CITY OF TONTITOWN PLANNING OFFICE

Meeting: **August 31, 2021**
Project: **Hickory Meadows SD**
Phase 2 Final Plat
Planner: Nathan Crouch

Hickory Meadows Subdivision, Phase 2

FINAL SUBDIVISION PLAT APPROVAL REQUEST

**FINAL PLAT FOR
HICKORY MEADOWS SUBDIVISION PHASE 2
TONTITOWN, ARKANSAS**

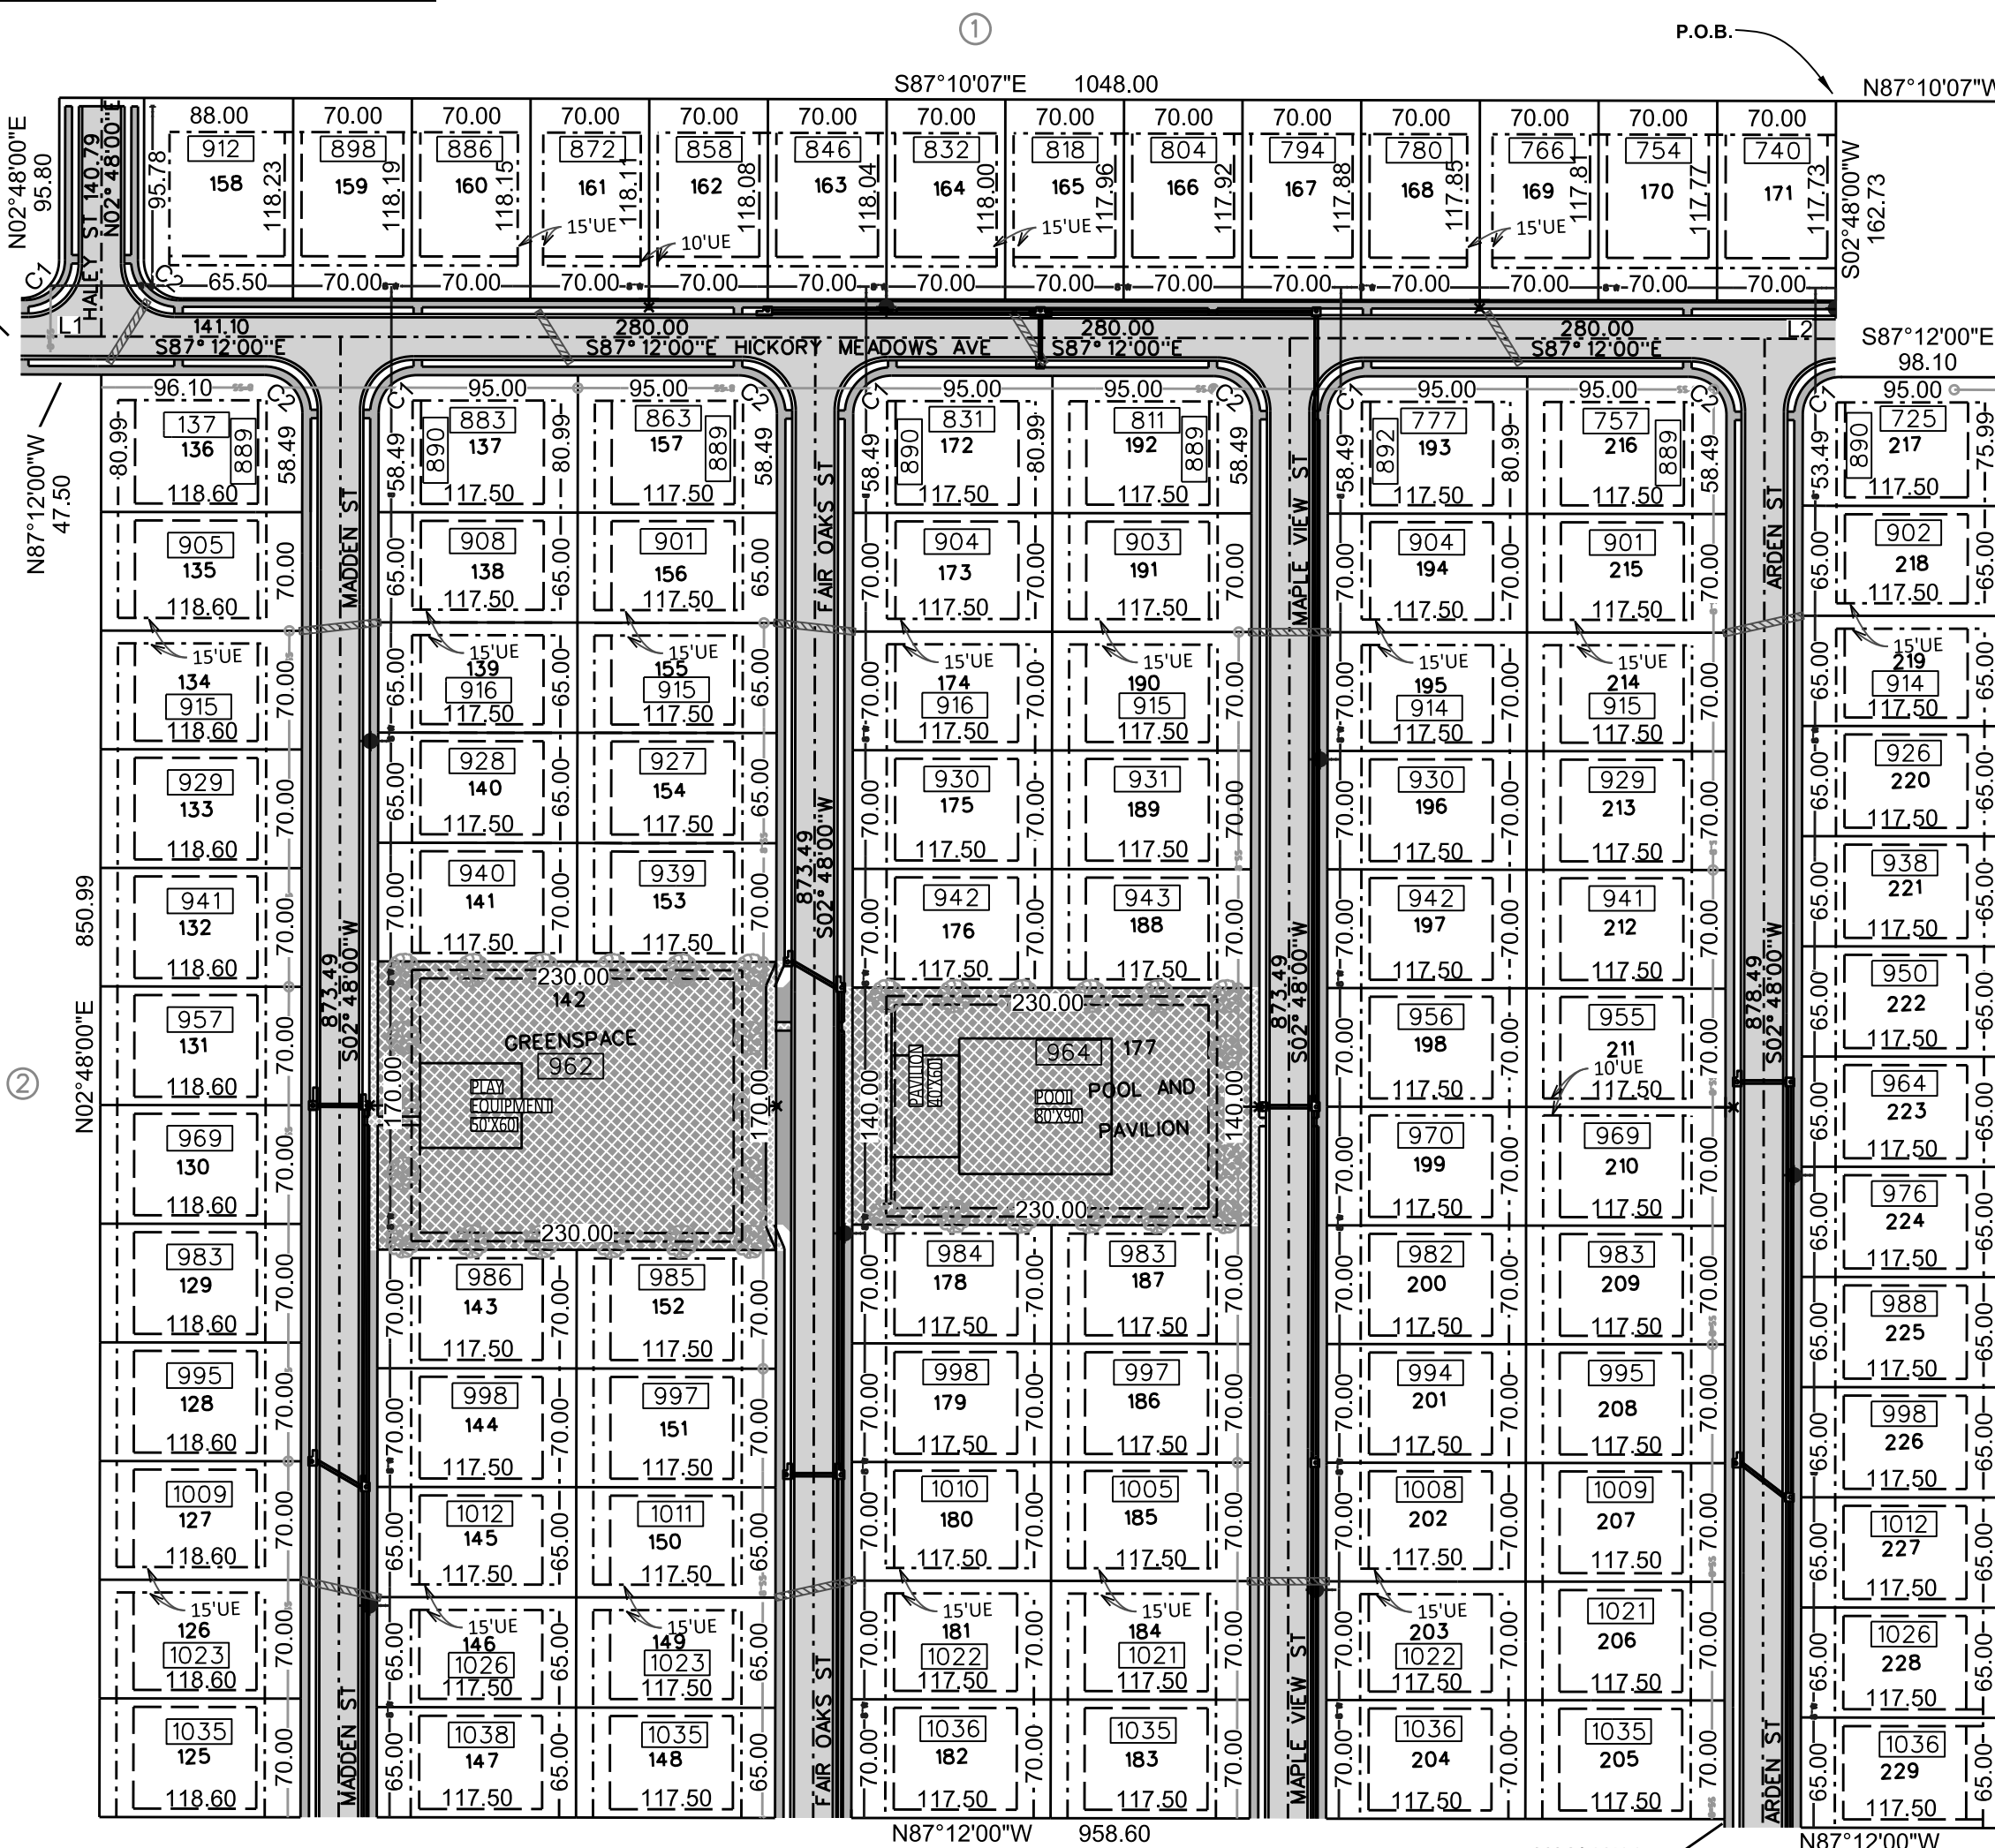
The Fire Marshal asked that the fire hydrants are shown on the final plat, and had no additional comments.

There was an issue with an ADA ramp for access to one of the common greenspace areas. Planning Staff has reached out to the City Attorney for advice and is waiting for his determination. The ramp didn't get built, and the question was whether it is actually required or if the project engineer can just remove it from the plans.

1. Show fire hydrants on final plat.
2. Bonds shall be submitted and reviewed for approval by the City prior to final signatures.
3. Several water taps need to be modified with extended connections.
4. Correct all remaining items on the "Plat Requirement Worksheet" prior to final signatures. Planning Staff will provide a copy of the remaining requirements to the project engineer.
5. No residential homes shall be constructed prior to filing the Final Plat.
6. Individual Residential Building Permits are required for each lot prior to individual residence construction.

If it is determined the ramp is required the developer has agreed to construct the ramp.
